AMENDMENTS TO THE DRAWINGS

REMARKS

The Claims Are Not Anticipated by U.S. Patent No. 4,753,641 by Vaslow ("Vaslow")

FIG. 8

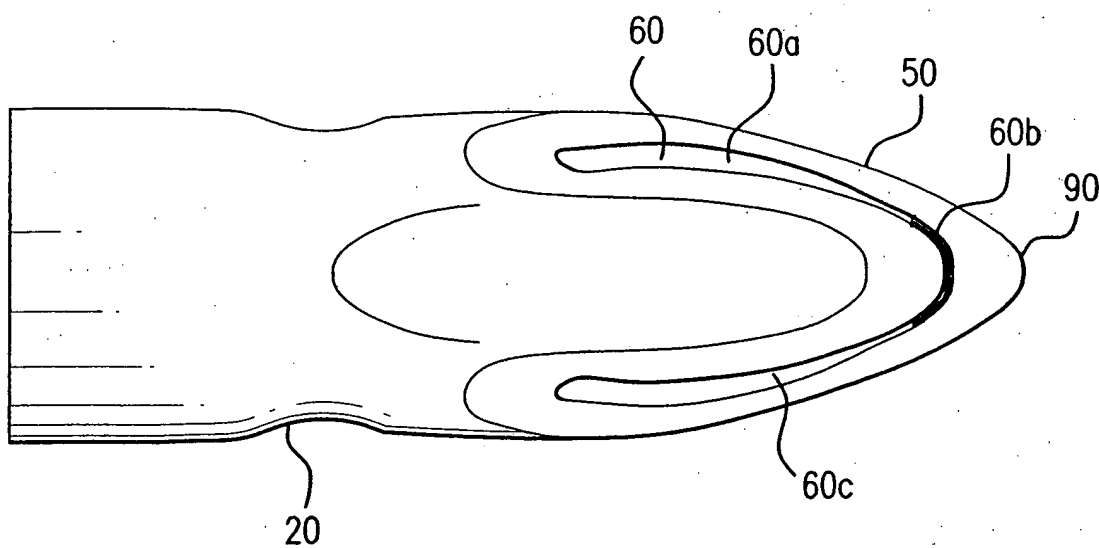
The attached sheet of drawings includes changes to Fig. 8. This sheet, which includes Fig. 7-8, replaces original sheet including Fig. 7-8. In Figure 8, the section 60b which was shaded in the original drawings was inadvertently not shaded in the formal drawings. This amendment is to add this shading back into Fig. 8.
